PJM Interconnection, L.L.C.
Docket No. ER23-1240-000

Issued: April 21, 2023

Re: *PJM Interconnection, L.L.C., Docket No. ER23-1240 -000*
Amendment to ISA, SA No. 5680; Queue No. AC1-120/AC1-121 (amend)

CUSTOMER FACILITY LOCATION/SITE PLAN

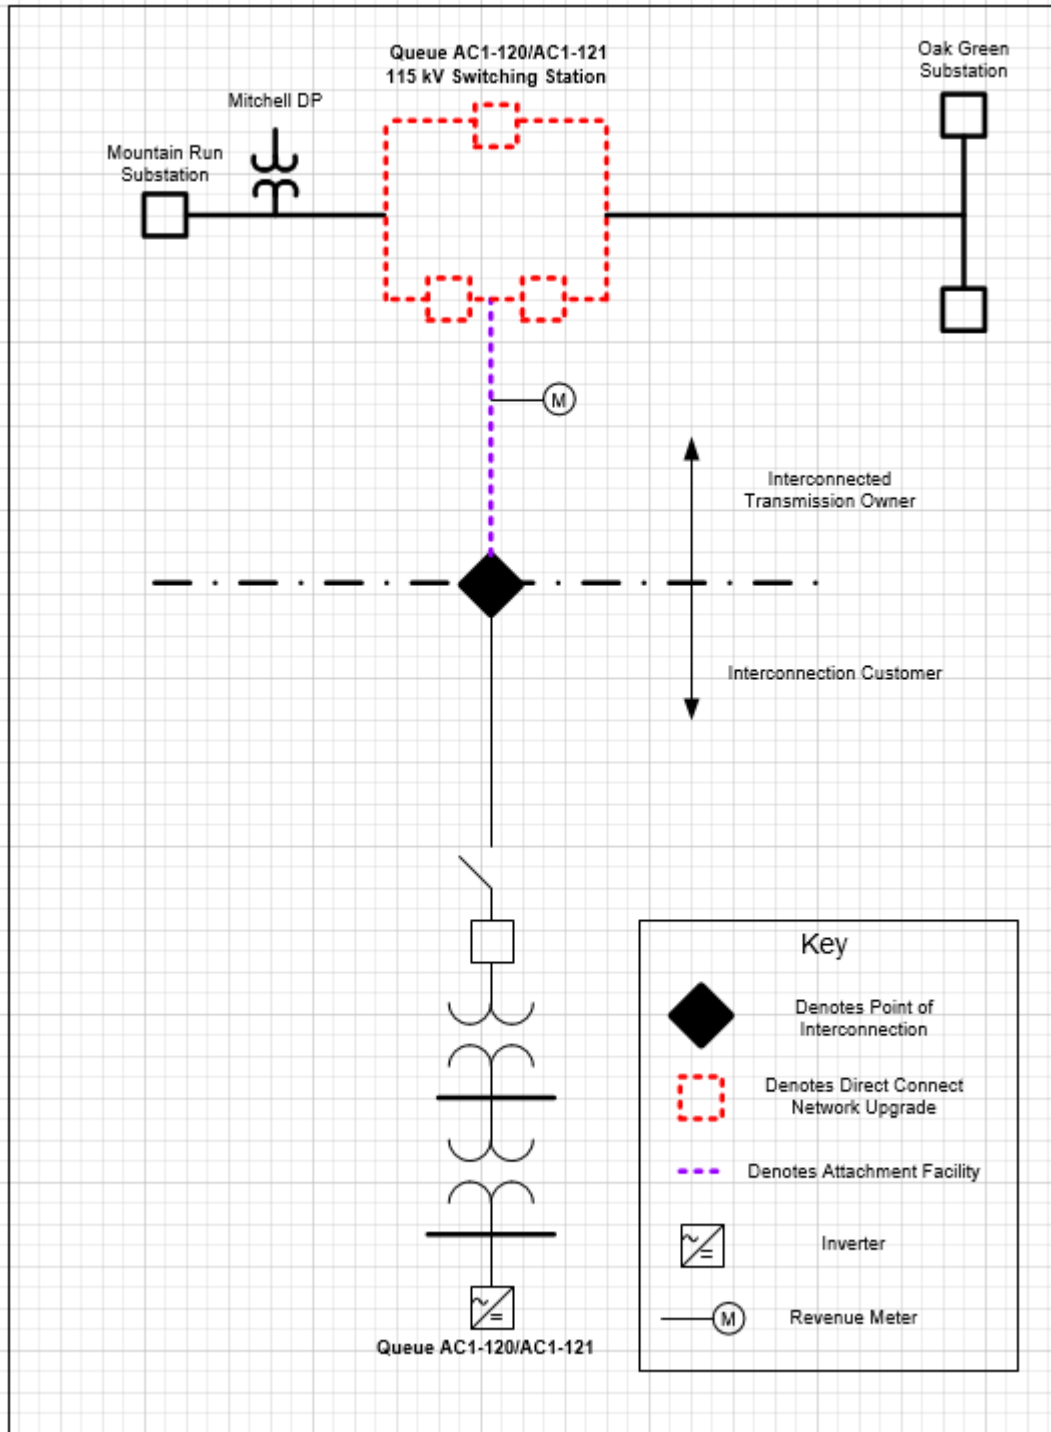
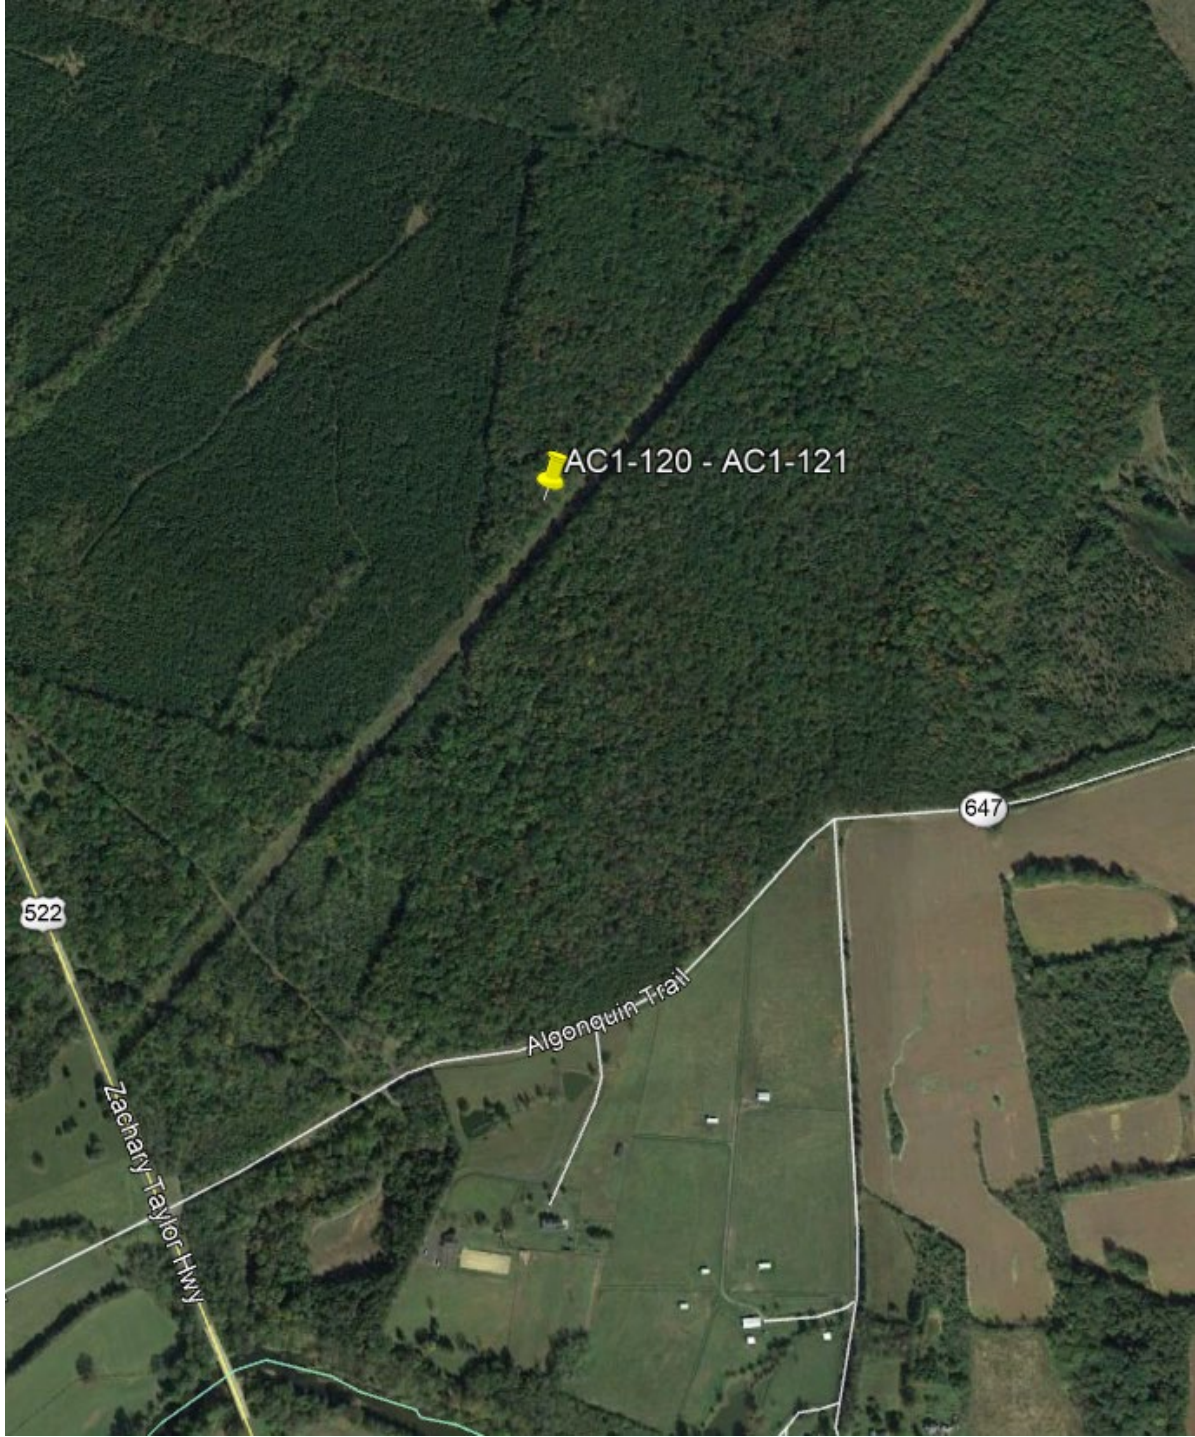
since the effective date of the Prior Sunfish ISA. First, the project changed its name from Cricket Solar LLC to Sunfish Solar LLC. Second, because of community opposition to the original project, Sunfish moved the location of its project from Culpeper County, Virginia, to Orange County, Virginia, which also involved a change to the project's Point of Interconnection. Third, Sunfish requested a scope change for the milestone dates for its project, and subsequently entered a suspension period that ended March 29, 2022 and then was re-instituted on December 23, 2022.

The Parties have entered into the Agreement to Amend and revised the Prior Sunfish ISA and the Prior Sunfish ICSA in order to address these changes. In order to address the project's name change, the references to Cricket Solar LLC have been replaced with references to Sunfish Solar LLC on the title page and first page, in sections 1.0 and 18.0, on the execution page and Specifications section, and title page, of the Revised Sunfish ISA. The name of the project has also been revised in Specifications section 1.0(a). Specifications section 1.0(b) and Schedules A and B of the Revised Sunfish ISA have been revised to reflect the new location, Point of Interconnection, and configuration of the Sunfish Solar Customer Facility. The description of the Direct Connection and Non-Direct Connection Network Upgrades in Specifications section 3.0(b) of the Revised Sunfish ISA has been modified for clarity to reference Queue Position No. AC1-121. Finally, consistent with Section 212.5 of the PJM Tariff, sections 6.1 through 6.4 have been modified to reflect the changes in milestones associated with the one-year suspension period that ended on March 29, 2022.⁸
